**Shenzhen DO Intelligent Technology Co., Ltd**

Ref: FCC Class II Permissive change for FCC ID: 2AHFT537

This is to request a Class II Permissive change for FCC ID: 2AHFT537 originally granted on 12/28/2023 (date).

**GTX15**

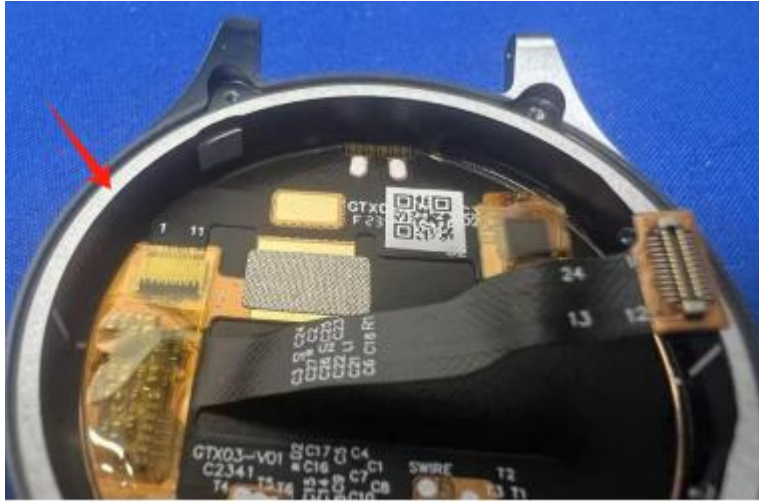
Antenna type: changed from metal frame antenna to LDS antenna

Antenna gain: changed from -2.74dBi to -2.1dBi

Because of the change in antenna type, a shrapnel has been added
